Pines Dining Hall + Servery Addition

Northern Health Authority

Addendum No. 2

DGBK Project No. 17-110

E200

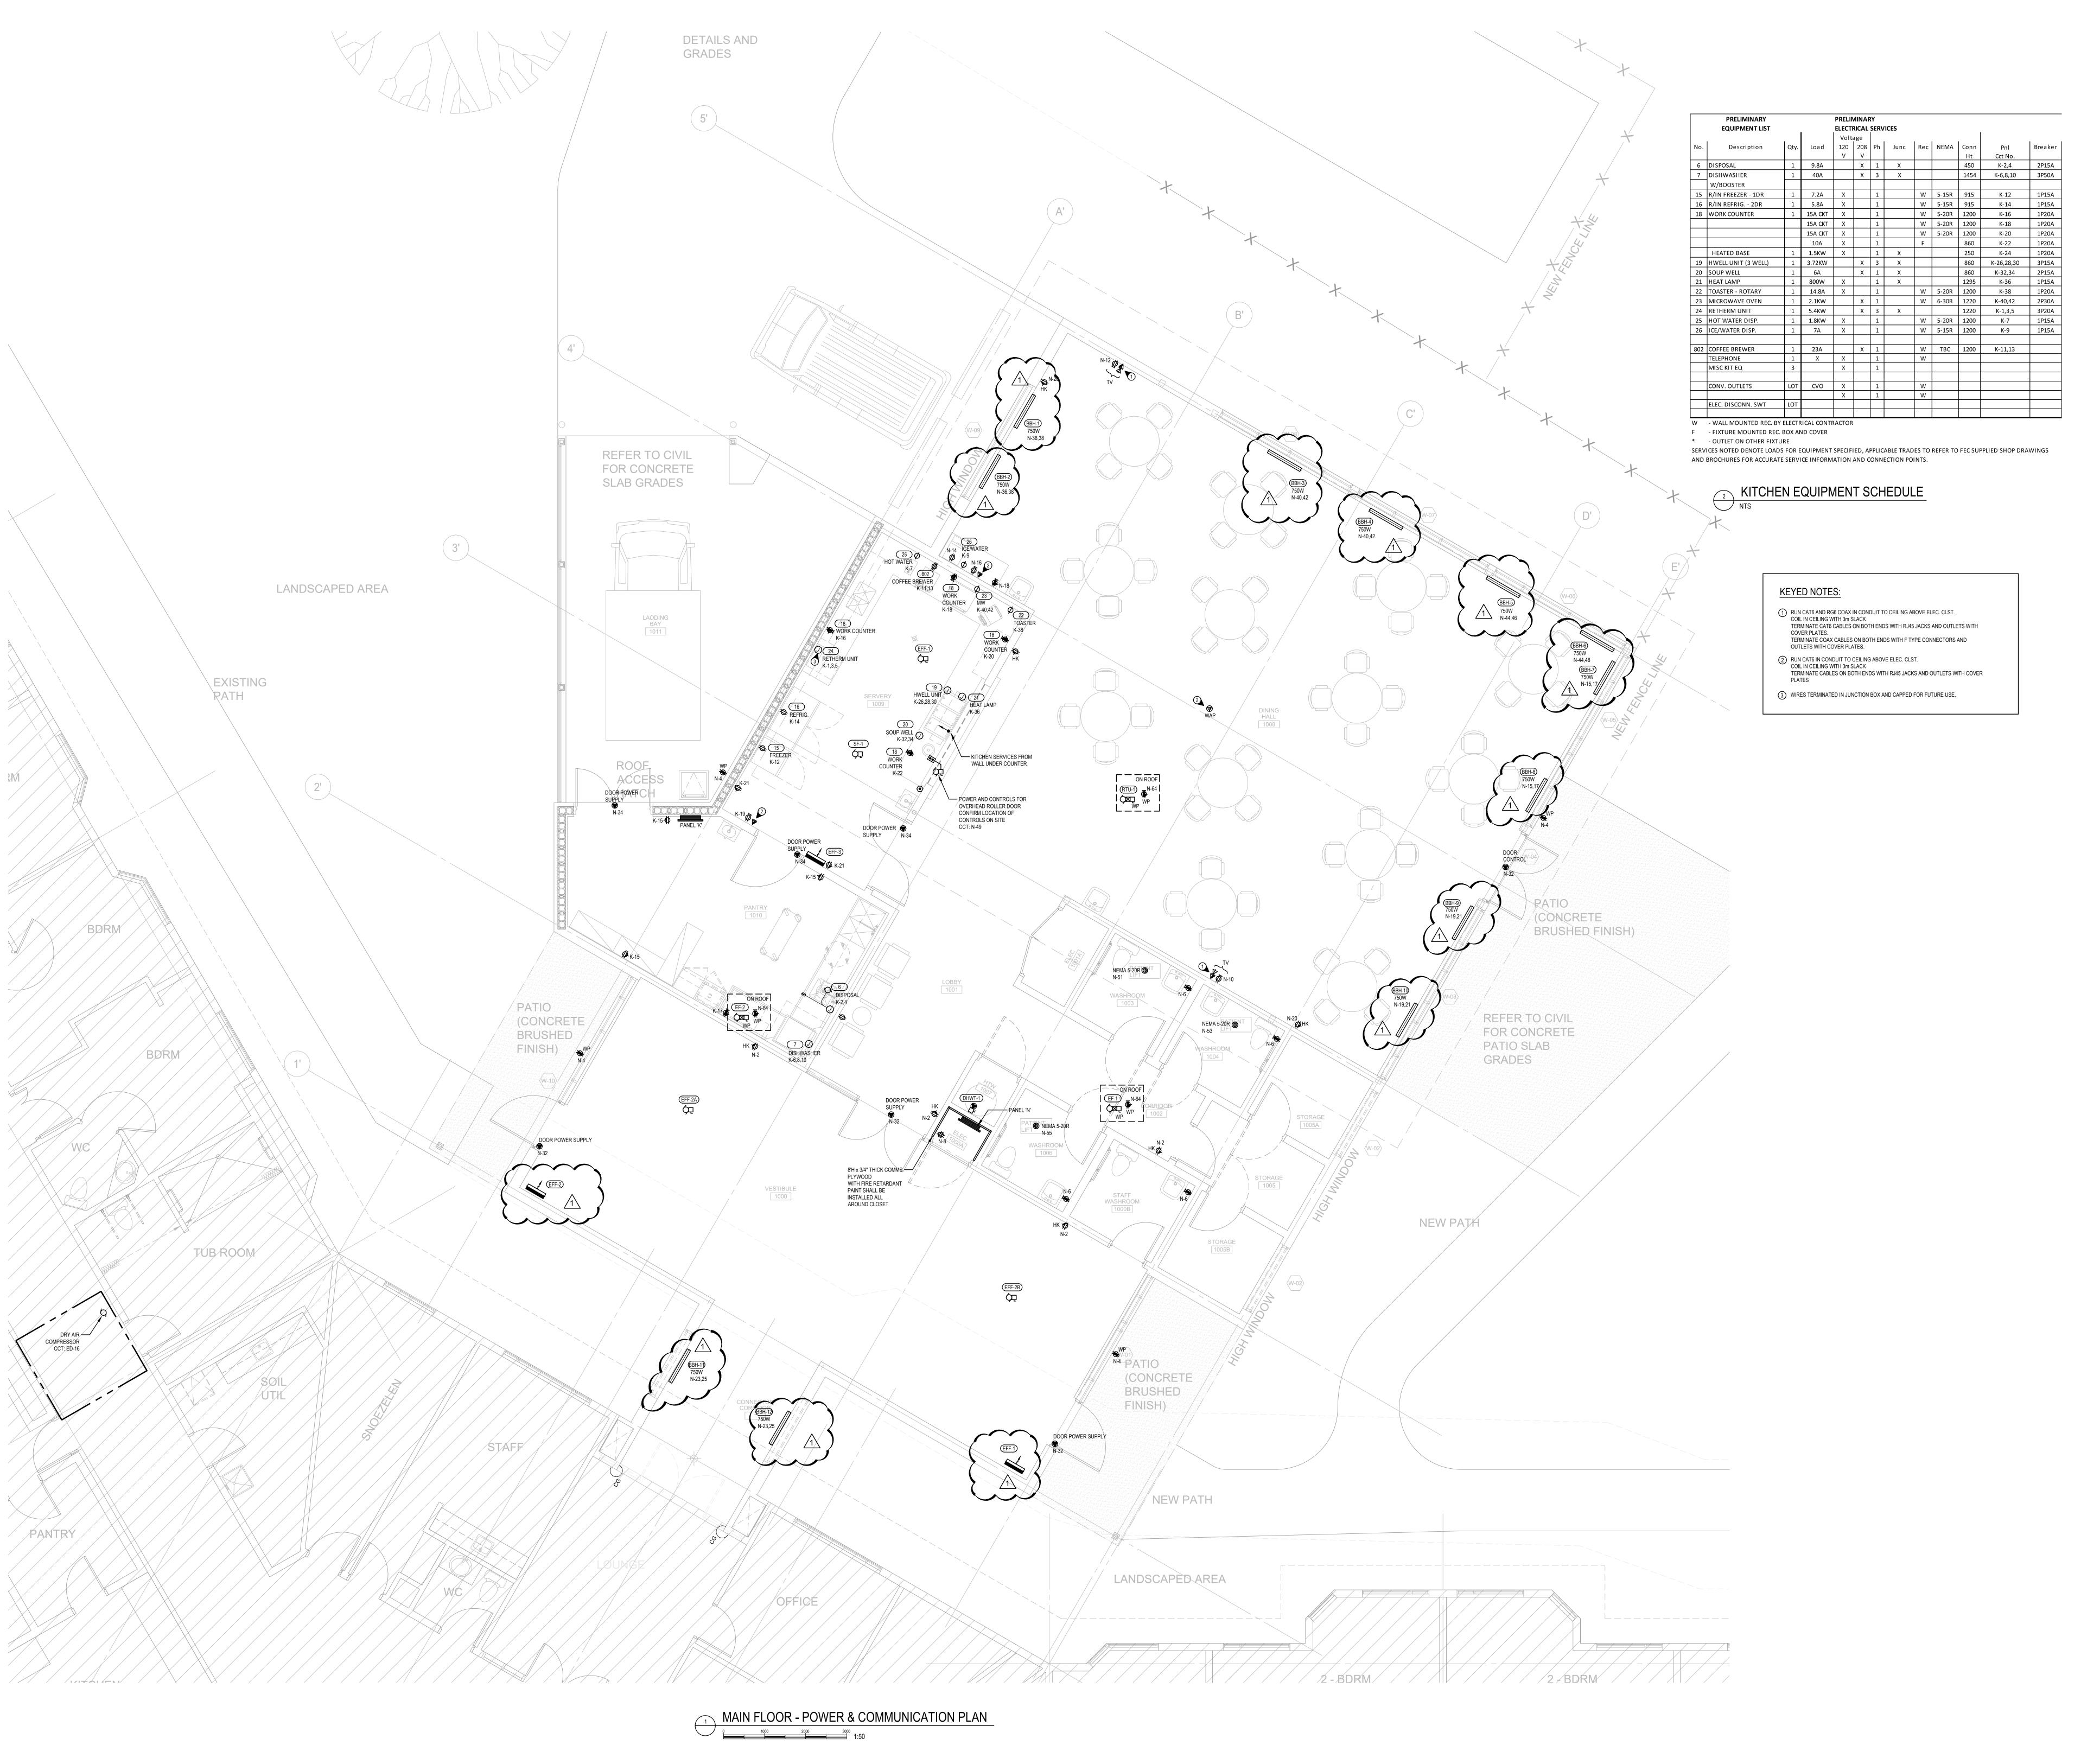
- .1 Two additional baseboard heaters have been identified on drawing.
- .2 Previous 1500W baseboard heaters have now been split into two 750W units as identified on drawing.
- .3 Two additional electrical forced flow heaters have been identified on drawing.
